# OPL2LPT and OPL3LPT : Compatibility improvement fix

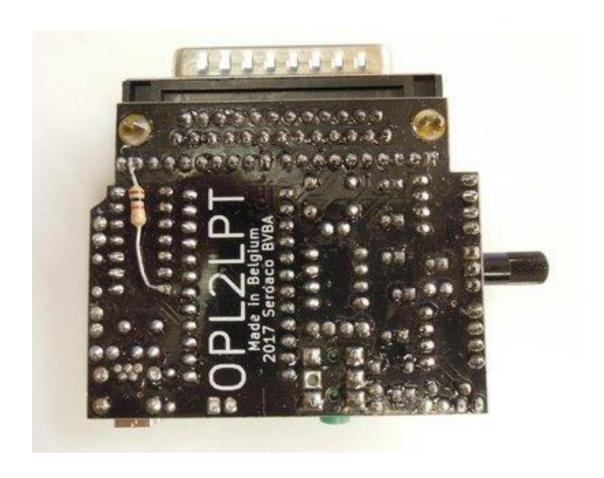
OPL2LPT and OPL3LPT run fine on most computers, but a few customers reported incompatibility with their parallel port. The following PC models so far, were found to be incompatible :

- PCJr
- PS/2 P70
- Dell 386sx-16
- Nec 386sx-16

This incompatibility can be easily and 100% fixed by adding a 1k pull up resistor to the strobe line. From now on, to maximize compatibility, OPL3LPT assembled PCB's will be sold with this modification already implemented. OPL2LPT solder kits will also include an additional 1k resistor.

Please find the photos below showing how you can add this 1K resistor, if needed.
